APPLICATION FOR PERMIT TO DRILL OR REENTER

2. Name of Operator RKI Exploration and Production, LLC.		7. If Unit or CA Agreement, Name and No.	
3a. Address 3817 NW Expressway, Suite 950 Oklahoma City, Oklahoma 73112		8. Lease Name and Well No. Longview Fed 6 #11	
3b. Phone No. (include area code) 405-996-5748		9. API Well No. 30.015-37326

**RKI EXPLORATION & PRODUCTION, LLC.
DRILLING PLAN**

PECOS DISTRICT CONDITIONS OF APPROVAL

FIGURE K4-2. Typical choke manifold assembly for 5M rated working pressure service - surface installation.

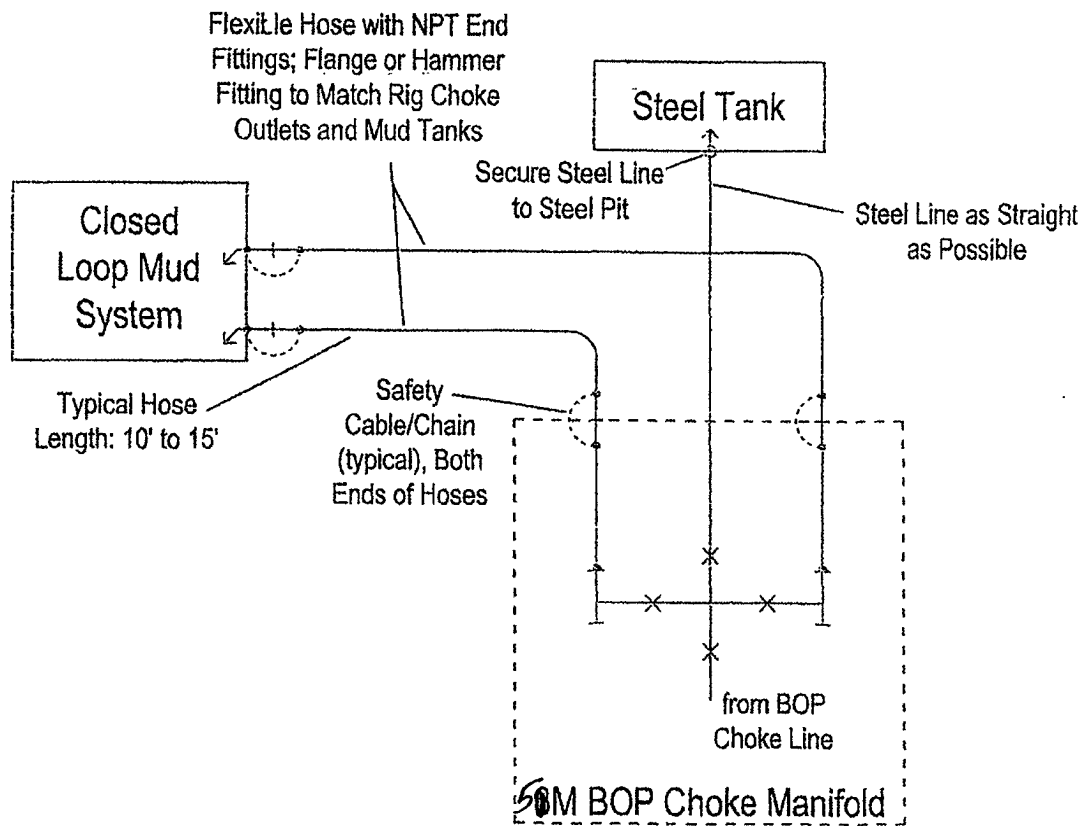
choke manifold on this diagram
does not meet 5M requirements
OKay for 2M.
